STAFF REPORT

TO: City Council
FROM: Emily Becker, City Planner
AGENDA ITEM: Lakewood Crossing 2nd Addition General Planned Unit Development
Concept Plan
REVIEWED BY: Stephen Wensman, Planning Director

A RESOLUTION APPROVING A PLANNED UNIT DEVELOPMENT CONCEPT PLAN FOR LAKEWOOD CROSSING 2ND ADDITION

Re: Lakewood Crossing 2nd Addition
Concept Plan Review

A2.1

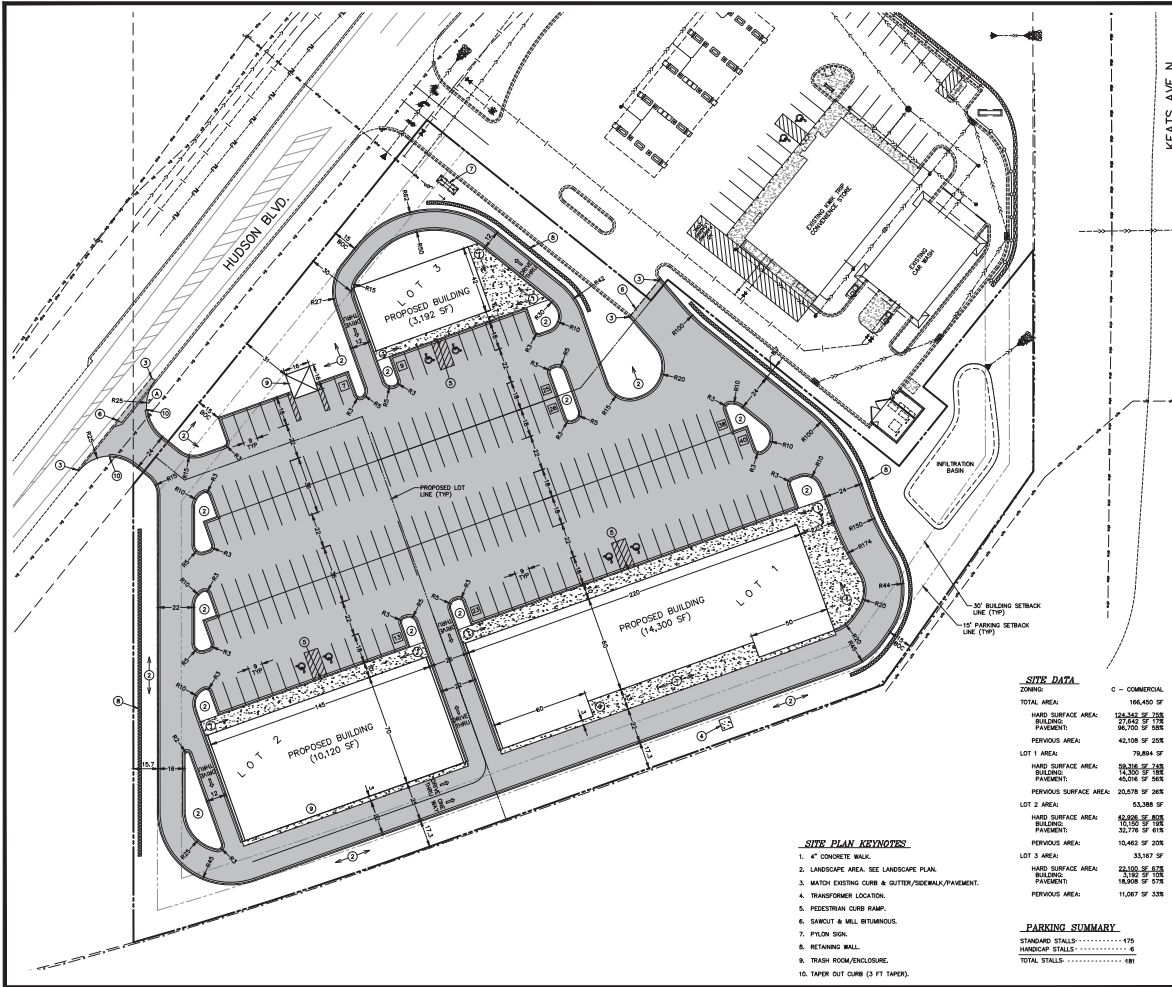
- *Drive-thru placement.* The Commission also had concern about traffic control with proposed placements of drive-thrus. Specifically, the northerly-most drive-thru exits in to the parking lot rather than providing egress. There was also concern about the number of drive-thrus, turning radiuses, and traffic control with the number of drive-thrus being proposed.

- *Orientation of buildings.* The unique shape of the parcel that is being developed resulted in a unique shape of Lot 3. As a result, the building is oriented according to the shape of the parcel and to accommodate better traffic circulation and proximity to the parking lot.
- *Landscaped open or gathering spaces.* Being that this a small commercial development located in close proximity to the highway that will likely serve quick visits, Staff does not feel it necessary to provide this open space. An outdoor dining area is being proposed, and the restaurants will likely provide adequate seating for guests.

10. The Applicant shall detail the location of the drive-thru elements and outdoor dining facility to ensure standards for such uses have been met.
 11. The Applicant shall submit a photometric plan, and all lighting must meet requirements of Sections 150.035-150.038 of the City Code.
